IMPORTANT SAFETY RECALL RECALL NO. 17E061

December 2017

This campaign involves the supercharger mounting bracket (Part Nos. AB037A-100, AB037A-100P, AB037A-100B) in ProCharger supercharger systems and kits, intended for installation on Model Year 2012 – 2017 Jeep Grand Cherokee SRT8/SRT vehicles in the US and Canada. These mounting brackets were included with the following kits:

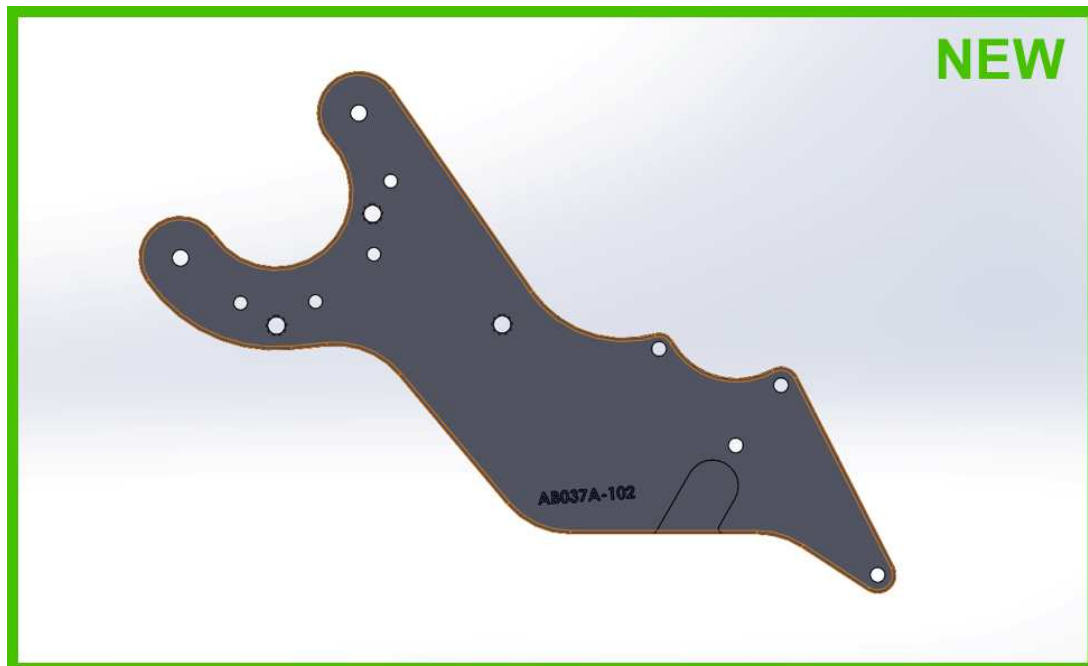
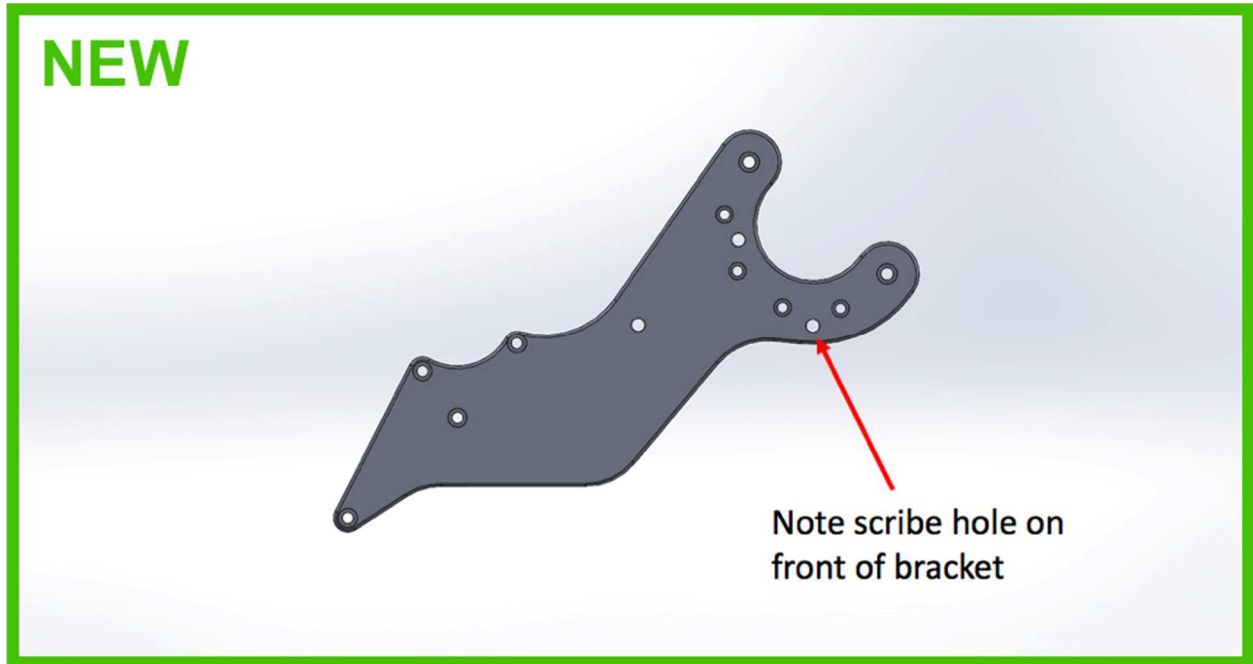
ProCharger has discovered that the compressor housing for the above listed applications may, over time, contact the ABS brake lines due to insufficient clearance afforded by the mounting. Contact with the brake lines could compromise the integrity of the line. This contact between the bracket and brake line can occur under a variety of circumstances including improper bracket installation, variation in the engine mount positions within the vehicle manufacturer's specifications (which potentially results in the bracket being placed close to the ABS line), and/or possible degradation of the motor mount over time that may increase movement of the engine. If this condition remains undetected, the compromised integrity of the ABS brake line could eventually result in loss of brake fluid and degraded braking performance, increasing the risk of a vehicle crash.
